NRC COMMENTS  
ON  
DOE DRAFT ENVIRONMENTAL ASSESSMENT  
FOR THE  
DAVIS CANYON SITE

March 20, 1985

NRC FIGURE 3-A AFTER DOE FIGURE 3-40

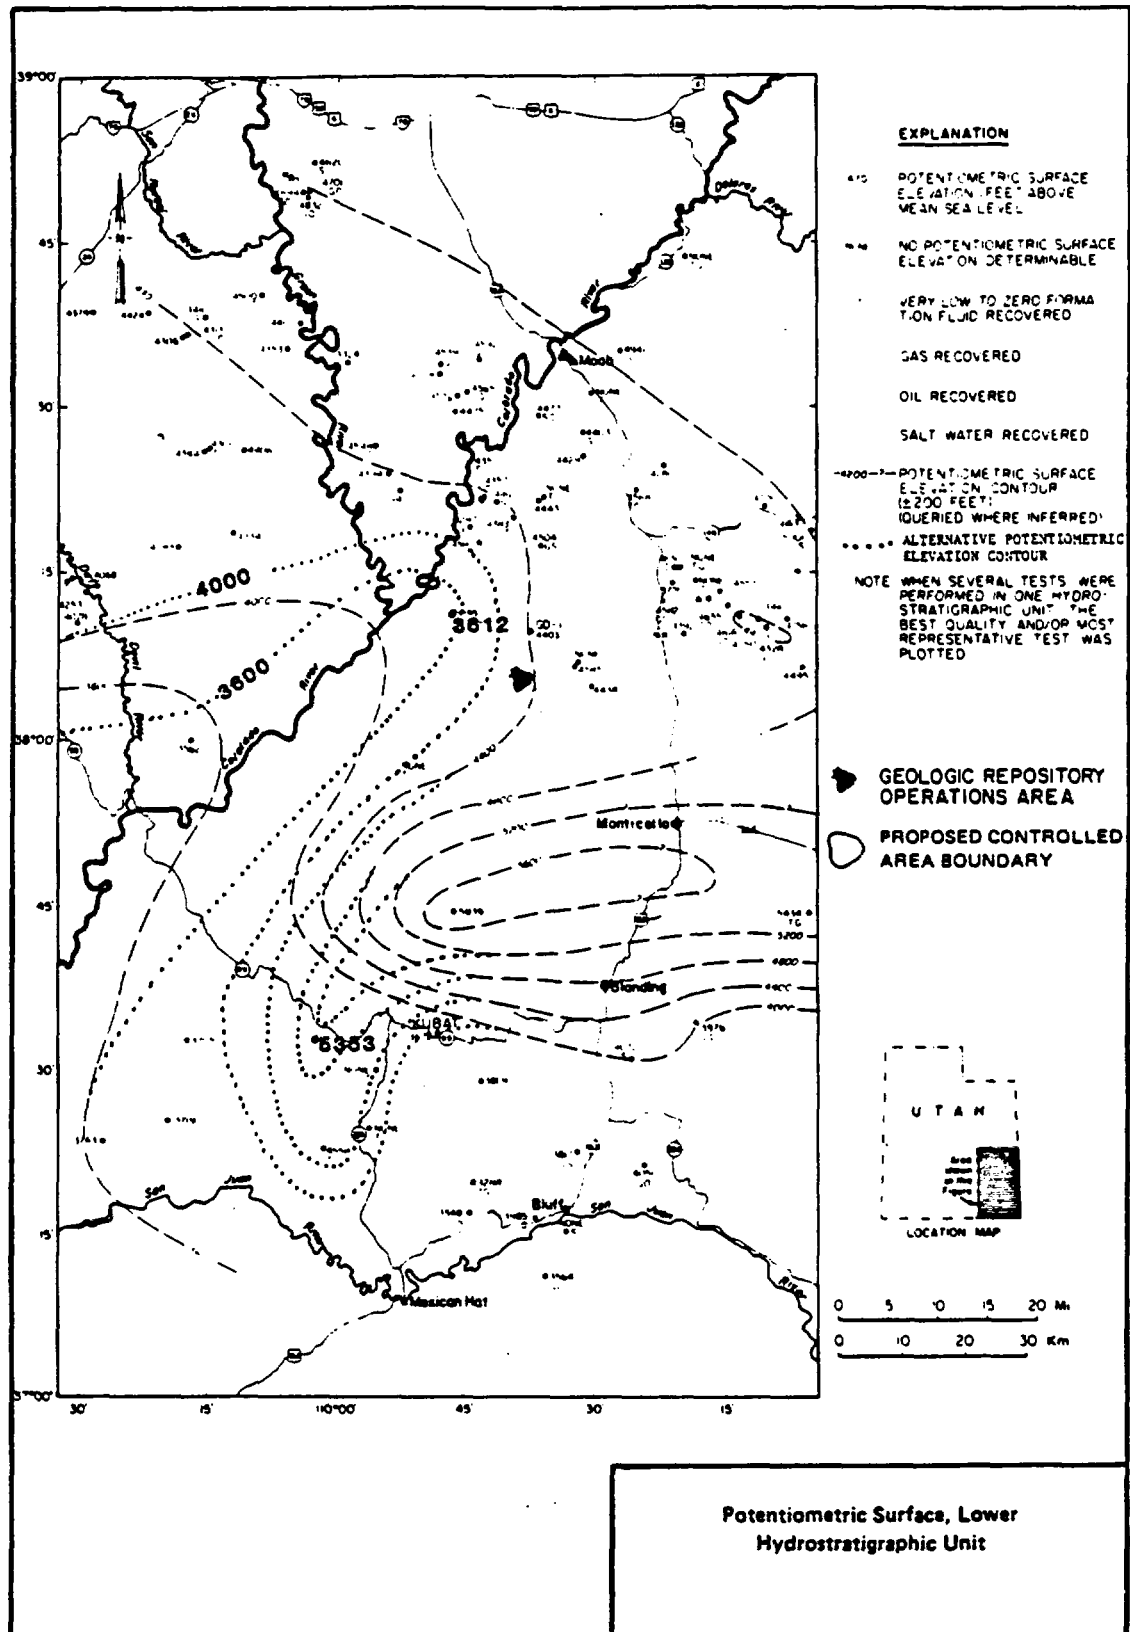
DOE presents a map (Figure 3-40) of the potentiometric surface of the lower hydrostratigraphic unit which includes incorrect values and inconsistencies when compared with the referenced data source (Woodward-Clyde, 1982, Vol. V, Appendix A). A revised potentiometric map based upon consideration of the concerns discussed below would alter flow direction to a northwest direction.

Figure 3-40 may include an incorrect head value. A well located immediately west of borehole GD-1 is labeled with a head value of 4,195 feet on Figure 3-40, but is listed at 3,612 feet in Appendix A (Woodward-Clyde, 1982, Vol. V). A change of the plotted value to 3,612 feet alters the shape of the potentiometric surface significantly by creating a major reentrant for the 4,000 to 3,600 foot contour lines. Given a revised potentiometric map based on this change, the flow path direction under the Davis Canyon site changes to a strong northwest trend; flow goes more directly toward the Colorado River.

There are additional discrepancies between Figure 3-40 and Appendix A. Some wells plotted in Figure 3-40 are not listed at all in Appendix A. For example, a well located near the northwest corner of the map area, with a head value of 4,379 feet, is not listed in the appendix. Conversely, some wells listed in the appendix are not plotted on Figure 3-40 or its earlier versions. For example, a well listed in Section 27 of T.37 S., R.17 E., apparently has not been plotted in the figure. If this well is plotted and the correct value is plotted for the well near borehole GD-1, the shape of the potentiometric surface is altered significantly. In addition, many of the wells listed in Appendix A (Woodward-Clyde, 1982), have head values obtained from testing more than one interval. A note on Figure 3-40 indicates that a selection process was used to determine which one of the values was to be plotted; however, no discussion is presented in Woodward-Clyde (1982) or the draft EA to explain the basis of the selection process. Selection of values other than those used could also significantly alter the potentiometric surface map.

Replotting of Figure 3-40 after the alterations described above can produce an alternative potentiometric surface for the Leadville Formation. The configuration of the alternative potentiometric surface map is presented below (see Figure 3-A). This alternative potentiometric map indicates the Colorado River may be a much stronger hydraulic sink northwest of the geologic repository operations area than was the case for the original map. The gradient between the repository and the river is steepened.

The higher gradient parallel to the Colorado River northwest of the repository site suggests that a permeability change may exist in the Leadville Formation in the vicinity of the junction of the Colorado and Green Rivers. Groundwater gradients frequently reflect permeability changes caused by structural features that control surface drainage.

Comparison of the alternative potentiometric surface map presented herein with the map shown in Figure 2 of Hanshaw and Hill (1968) reveals a similar magnitude and direction of gradient on both maps. Unfortunately, however, Hanshaw and Hill do not show data points on their map. Another difference between the draft EA potentiometric map and the Hanshaw and Hill map which will require further clarification as site characterization proceeds is the nature of recharge to the lower hydrostratigraphic unit in the vicinity of the Abajo Mountains.

Section 3.3.2.1, Hydrology and Modeling, Page 3-133 to Page 3-135, Table 3-12

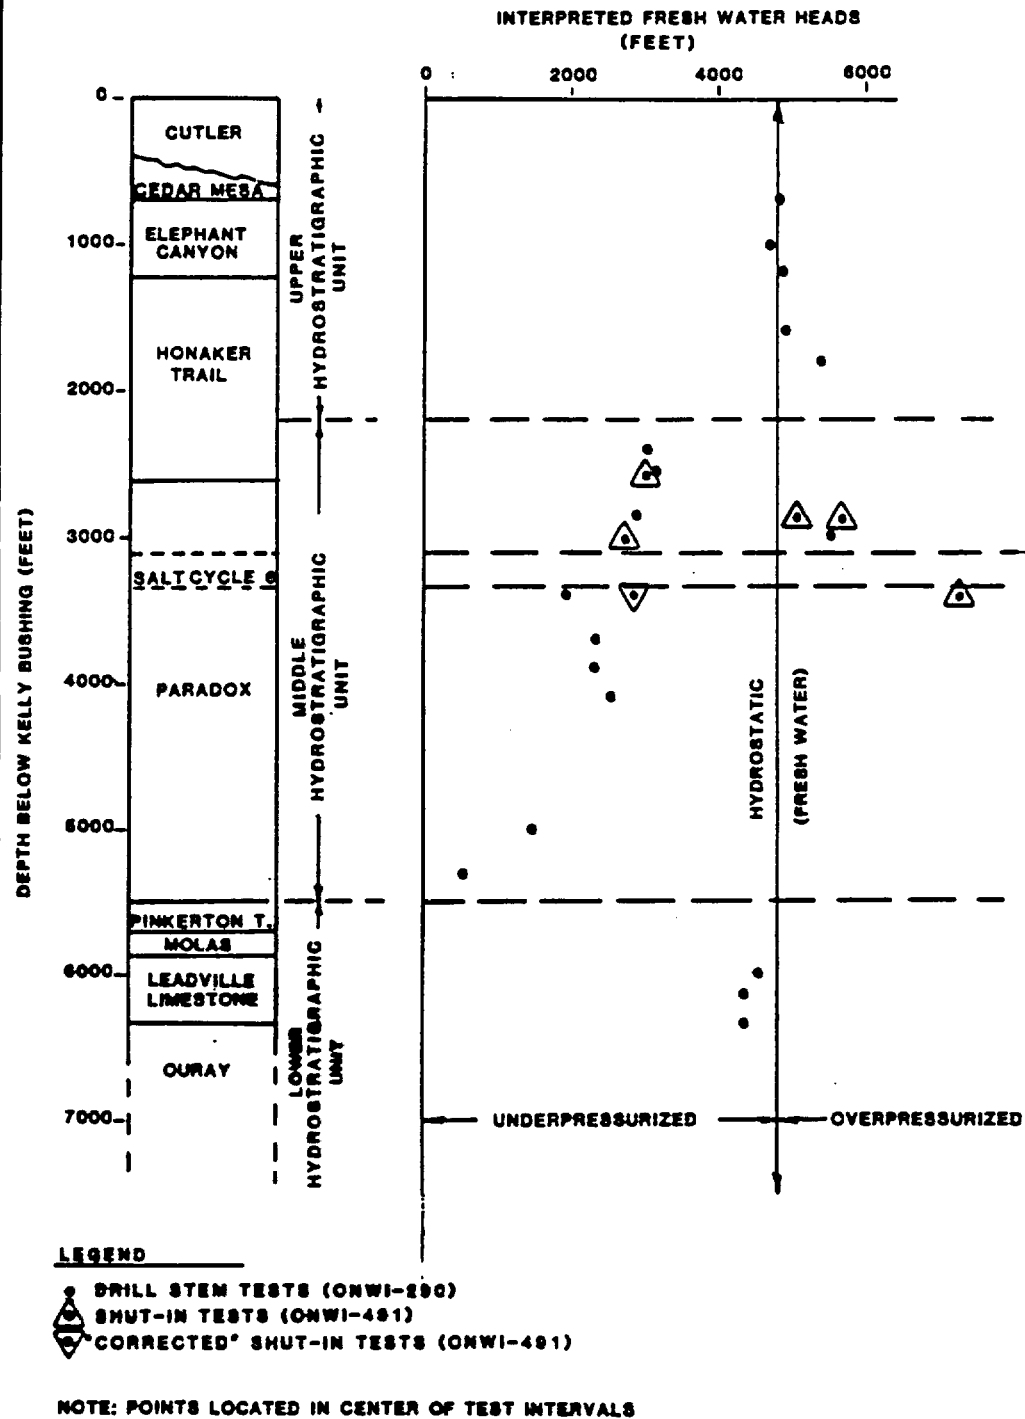
This Table does not show all potentiometric head data collected by DOE at borehole GD-1 which are used to support conclusions in the draft EA. If the potentiometric and estimated static reservoir data collected in the second series of tests (August-September, 1982) at borehole GD-1 were added to this table, complete consideration of the range of possible interpretations of gradient and flow direction for the middle hydrostratigraphic unit would be facilitated.

Head data from borehole GD-1 are variable. Figure 3-B (on previous page) depicts the short-term drill stem test head data (data points shown as circles) presented on Table 3-12 of the draft EA which were collected at borehole GD-1 from March 1980 to January 1981. The figure also shows the long-term shut-in test data (shown as triangles) collected at borehole GD-1 during August-September 1982 (Thackston, et al., 1984, Table 4-2). The Figure indicates that the potentiometric head profiles within each of the upper and lower hydrostratigraphic units each separately conform to a hydrostatic profile 0.4333 psi/ft (Thackston et al., 1984, p.11). In contrast, head within the Paradox Formation varies considerably with depth. The NRC concludes that consideration of the long-term test data increases the variability of measurements significantly. The long-term test data can be interpreted to indicate several alternative hydraulic conditions at borehole GD-1, including overpressurized and underpressurized conditions, as well as the possibility of localized upward and downward gradients. If there is localized vertical interconnection in these units, these head data suggest that there may be localized downward and upward flow. Hydrochemical data from borehole GD-1 may further substantiate the potential for localized upward gradients between the middle and upper hydrostratigraphic units (see detailed comment 3-29).
